# Access Compliance Report

## Public Rights-of-Way

Intersection ID: 49136	Main Street: AMBER_LEIGH_WAY_DR	Cross Street: POPE_FARM_RD	Location:	N
ADA ID: E26A3020E25D	Ramp Type: Perp	Initial Pass/Fail: Fail	Overall Compliance: No	Severity Score: 1.25
Codes/Mitigation Info/Possible Solution		Field Measurements/Component Compliance

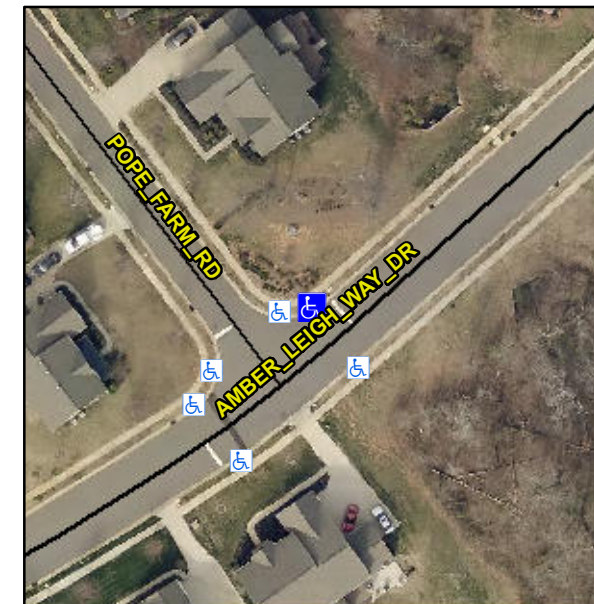
**Remove & Replace Entire Ramp.**

**R304.5.3**

Compliance	Description	Data	Compliance	Description	Data
N/A	Ramp Length (in)	48.0	Yes	Ramp Slope (%)	7.6
Yes	Ramp Width (in)	48.5	No	Ramp XSlope (%)	4.1
N/A	Flare Type LT	N/A	N/A	Flare Type RT	N/A
N/A	Flare Slope LT (%)	N/A	N/A	Flare Slope RT (%)	N/A
N/A	Flare Traversable LT?	N/A	N/A	Flare Traversable RT?	N/A
N/A	Landing Length (in)	N/A	N/A	DWS Provided?	N/A
N/A	Landing Width (in)	N/A	N/A	DWS Contrast?	N/A
N/A	Landing Slope (%)	N/A	N/A	DWS Length (in)	N/A
N/A	Landing X Slope (%)	N/A	N/A	DWS Full Width?	N/A
N/A	Landing Curb? (Y/N)	N/A	N/A	DWS Offset (in)	N/A
N/A	Shared Landing?	N/A			
N/A	Gutter Ponding?	N/A	N/A	Gutter Slope (%)	N/A
N/A	Gutter Lip Ht (in)	N/A	N/A	Gutter X Slope (%)	N/A
N/A	Painted X Walk1?	No	N/A	Painted X Walk2?	N/A
	X Walk 1 Direction	To SE		X Walk 2 Direction	N/A
N/A	X Walk 1 Width (in)	N/A	N/A	X Walk 2 Width (in)	N/A
	X Walk 1 Slope (%)	4.9		X Walk 2 Slope (%)	N/A
	X Walk 1 X Slope (%)	3.2		X Walk 2 X Slope (%)	N/A
